SQA-8569 – Traffic Signal Supplementary Report

Name:	Cycle Enfield – A105 Corridor Scheme		
Type of Scheme	TfL Cycling Programme -Mini-Holland Scheme		
Borough	Enfield	Road Network (TLRN/SRN/Other):	SRN
Location and Scope of works:	<p>Significant modifications are proposed at the junctions listed in Section 5.2, with cycle facilities provided to improve safety for cycling. Where possible improvements have also been made to pedestrian facilities, whilst minimising the impact of general traffic and buses.</p> 		
<p>Scheme Details:</p> <p>The proposed junctions have features including</p> <ul style="list-style-type: none"> • Separate cycle phases, either on-carriageway, or on footway, in one instance. • Early-release • 2-stage right turns • Advanced stop lines <p>Cyclists are protected through timing/movement separation. Details of the proposed layouts and designs can be found in the reports and other information listed in the 'Information Supplied' section.</p> <p>A two locations, signals have been introduced to replace a roundabout, to protect cyclists, predominantly left hooks at Edmonton Green Roundabout (Church Street/Fore Street/The Green (32/TBC) and Hertford Road/Bury Street

32/053 A1010 Fore St by Bridge Rd Pedestrian Crossing

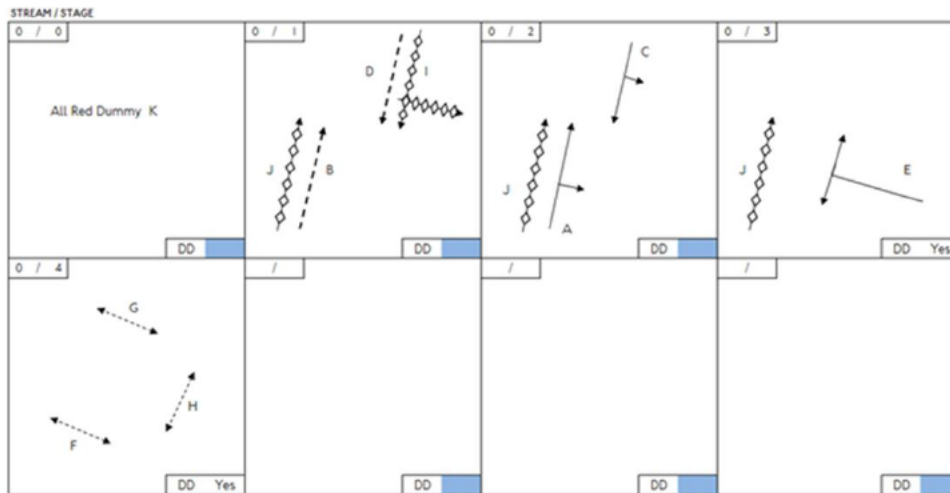
The scheme proposes to make changes to the existing signalised Toucan crossing which is to be retained with modifications at the northern and southern approaches of this junction to provide an improved layout for the cyclist movements.

A cycle lane is to run through the crossing on the West side, this will have its own low level cycle signal and share the vehicle stop line. On the East side the cycle lane is to be off-carriageway and run through a shared area. The crossing is proposed to use PC@TS. There are to be pushbuttons on all four corners of the crossing.

32/111- Hertford Road - Edmonton Green - Balham Road

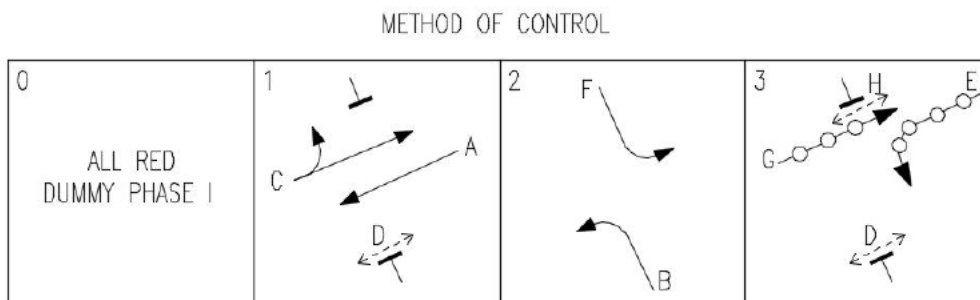
This junction is to be modernised and the layout will be changing. The main changes are the staggered crossing is to be removed and the crossing point moved toward the new roundabout. The crossing is becoming a straight across crossing in two parts with PC@Ts. Another change to the layout is the new lane for westbound cyclists, which crosses both carriageways. Balham road is now to be signalised, with pedestrian facilities and PC@Ts. There is SCOOT currently on site but will need to be adjusted to for the new layout, it is to be retained. There is also an eastbound segregated on carriageway cycle lane which leads to the bi-directional off carriageway cycle track. PC@Ts will also be provided for the crossing exiting the bus station.

32/195- A1010 Hertford Road - Edmonton Green Bus Station Northern Junction

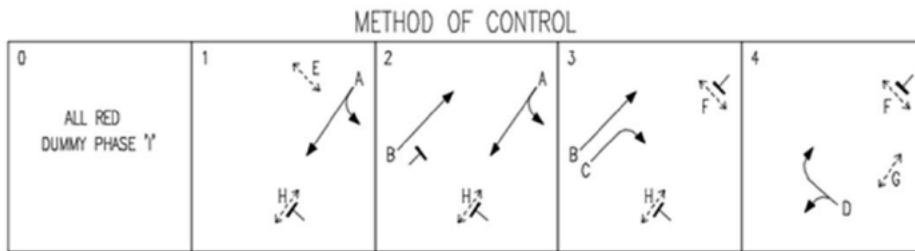
There are no changes to the junction in terms of signal works but there will be major changes to the layout as there will be an addition of a bi-directional cycle track on the northern footway. There will also be a removal of a northbound ASL and a non signalised stopline. Existing SCOOT is to be retained.

32/231 – Edmonton Green Roundabout – Church Street – The Green – The Broadway

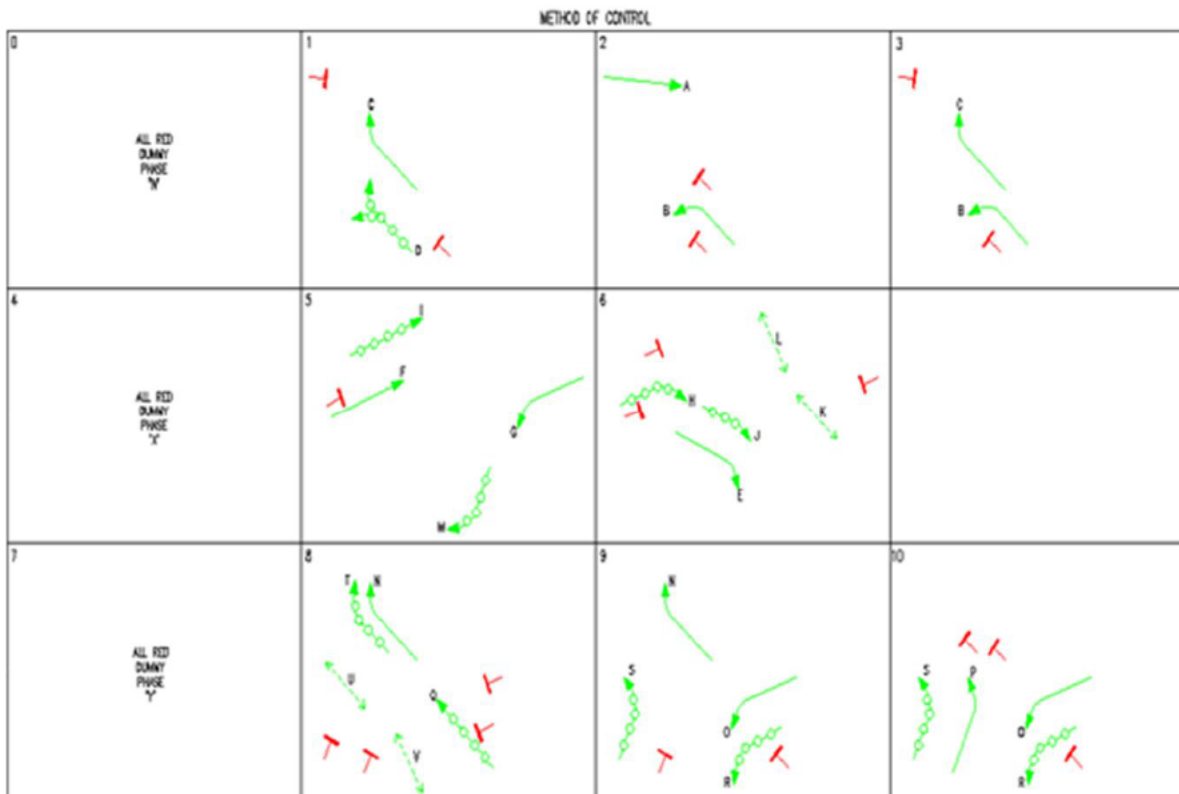
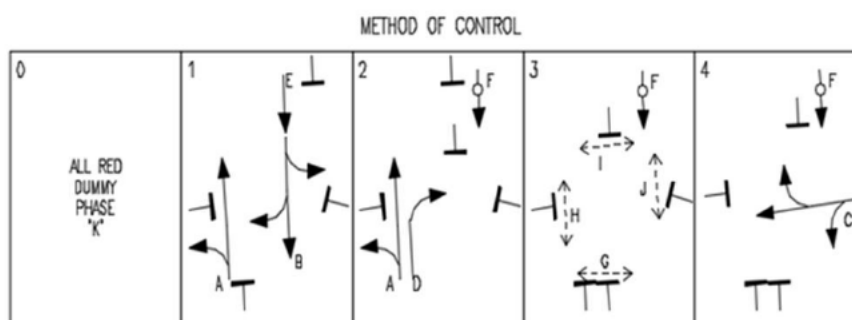
This is a new site which will significantly alter the roundabout's current layout. The introduction of multiple islands and cycle lanes will significantly reduce the roundabouts existing capacity, reducing it to a single circulatory lane. These islands will be used to provide segregated cycle facilities on all entries and exits from the gyratory. Cycle signals will also be provided on the circulatory at all potential conflict points with vehicular traffic. The roundabout is to have multiple cycle stop lines which will potentially hinder cyclist progression and may lead to non-compliance to the cycle signals causing them to exit segregation in order to progress. The roundabout proposal is to utilise signals on each of the three arms of the gyratory. These will run as separate streams.

The first stream is on the Church Street arm of the junction and includes vehicular and cycle movements. This is the only arm that provides no pedestrian facilities as there is a separate existing pedestrian crossing in close proximity to the roundabout, under the bridge. This crossing has a significant amount of bird excrement on it and has previously been raised as a health and safety concern to Enfield council. There will need to be some mitigation put in place as part of this project. There is also concern with left turning traffic exiting the roundabout on the first and third streams. Traffic can pass the left turn stopline in the right hand lane on the circulatory and then turn left exiting the roundabout past the stopline potentially without visibility of the signals and pass through cycle and pedestrian movements uncontrolled. Jacobs have stated that they intend to mitigate this issue with the use of wands to provide the necessary segregation and deter incorrect use of the exiting traffic.

The second stream on the roundabout is the northern intersection with The Green. This stream also has vehicular and cycle movements as well as a staggered pedestrian crossing. This is a straight over staggered pedestrian crossing which does not meet TI's current standards as there is a 5 metre internal clearance rather than the required 7 metres. This risk has been mitigated by the MOC being restricted so that both phases of the staggered crossing will start and terminate together, acting as one crossing. This will mean that the risk of see through is eliminated. Buses will exit the second stream and enter the bus terminus. This un-signalised left hook has a dedicated cycle stopline and signals to ensure there is no conflict with cyclists on the circulatory. The third stream is the southern junction with The Broadway. This arm is much the same as the second stream, with a sub standard straight over staggered crossing. All of the proposed crossing points are to have PC@T facilities provided. The site is to have a maintenance bay within the roundabout which will have immediate access to the junction controller and a secondary ESP. The site will operate under UTC SCOOT to allow for the optimisation of the signal timings.

The site is in the middle of Edmonton Green tube station, bus terminus and shopping centre. Works on this site will cause significant disruption.

32/018 Hertford Road / Bounces Road / Croyland Road

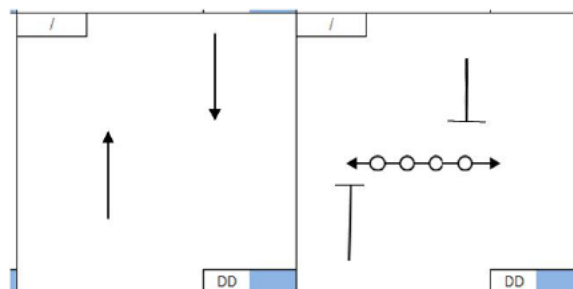
The need for safety and priority for cyclists' progression through the junction of A1010 Hertford Road/Croyland Road/Bounces Road has resulted in the junction modification.

Croyland Road will be converted to one-way eastbound (EB) between the junction of Hertford Road and Millbank Road. The restricted inbound movements from Croyland Road will be diverted via Bury Street to access the A1010 corridor

The SB approach to the junction is proposed to be converted from two lanes to single lane approach to accommodate the southbound cycle lane.

The SB right turning movements from the A1010 to Croyland Road is to be banned. This will provide additional capacity by not blocking the straight-ahead traffic movements. This change in the junction operation will also improve the safety of NB vehicles turning right at the junction, which will no longer be opposed to the SB right turn movement.

On the SB approach, there is a cycle gate with 18m storage, to be fed from a segregated nearside cycle lane.

On the NB approach, an advanced stop line (ASL) is provided with 7.5m storage fed by nearside mandatory cycle lane, this approach will have a 4 sec early release for cyclists.

Due to the presence of the ASL and storage on the NB approach of the junction, the exit-only gate of the petrol filling station located at the south-east corner of the junction is to be restricted to left turning movements only

The width of the pedestrian crossing facilities across Hertford Road will be widened to 4.0m.

An advanced stop line (ASL) facility with 5m storage is provided at the Bounces Road.

32/230 Hereford Road/Bury Street/Rosemary Avenue

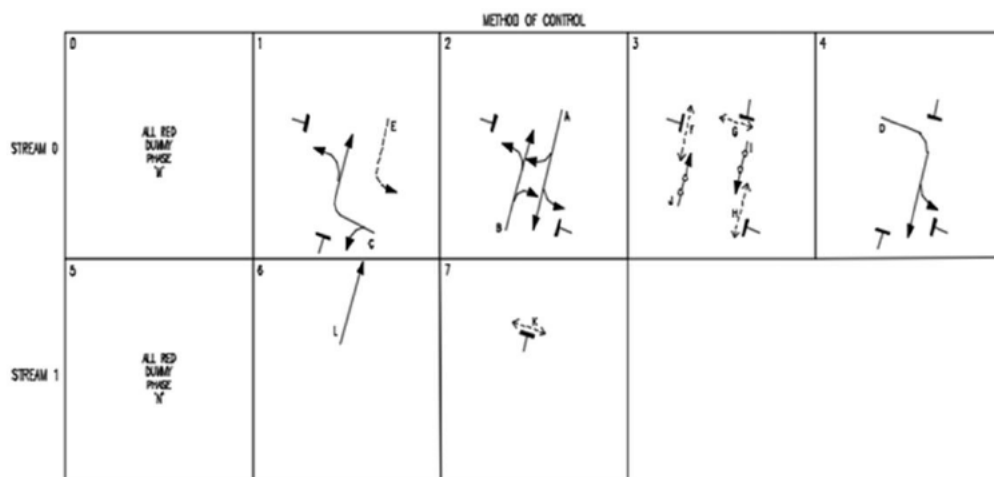
The scheme proposed to introduce a new signalised junction to replace the existing mini-roundabout. A segregated cycle lane will be built and run north controlled by its own dedicated cycle signal. Also, cycle holding areas will be created a signalised to allow cyclists to be ahead of general traffic at specific conflict points at the junction. This proposed design is too predominantly to mitigate the potential left turn hook conflicts between general traffic and ahead cyclists.
